Access Compliance Report Public Rights-of-Way (Curb Ramps)

Main Street: BENJAMIN_DR Cross Street: CHANTILLY_LN Location: NW

ADA ID: RPRK211020154846 Ramp Type: Type 4 - Parallel Initial Pass/Fail: Fail Overall Compliance: No Severity Score: 45

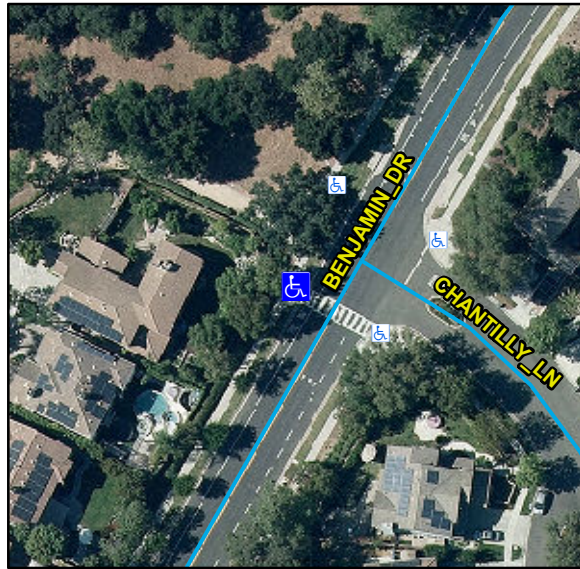
R204.3, R304.5.3, R304.3.2, STD 1115

Compliance	Description	Data	Compliance	Description	Data
N/A	Ramp Length LT (in)	126	N/A	Ramp Length RT (in)	138
Yes	Ramp Width LT (in)	65	Yes	Ramp Width RT (in)	65
Yes	Ramp Run Slope LT (%)	0.6	No	Ramp Run Slope RT (%)	12.4
No	Ramp Cross Slope LT (%)	6	No	Ramp Cross Slope RT (%)	5
N/A	Landing Present	N/A	N/A	DWS Provided	N/A
N/A	Landing Length (in)	N/A	N/A	DWS Contrast	N/A
N/A	Landing Width (in)	N/A	N/A	DWS Length (in)	N/A
N/A	Landing Run Slope (%)	N/A	N/A	DWS Full Width	N/A
N/A	Landing Cross Slope (%)	N/A		DWS Offset Type	N/A
N/A	Landing Movement Obstructed?	N/A	N/A	DWS Offset Left (in)	N/A
	Landing Movement Type	N/A	N/A	DWS Offset Right (in)	N/A
N/A	Landing Shared	N/A			
N/A	Clear Space	N/A			
N/A	Clear Space To Crosswalk (in)	N/A			
N/A	Marked Crosswalk 1	Yes	N/A	Marked Crosswalk 2	N/A
	Crossing 1 Direction	SE		Crossing 2 Direction	N/A
	Marked Crosswalk 1 Width (in)	144		Marked Crosswalk 2 Width (in)	N/A

Remove & Replace Entire Ramp.
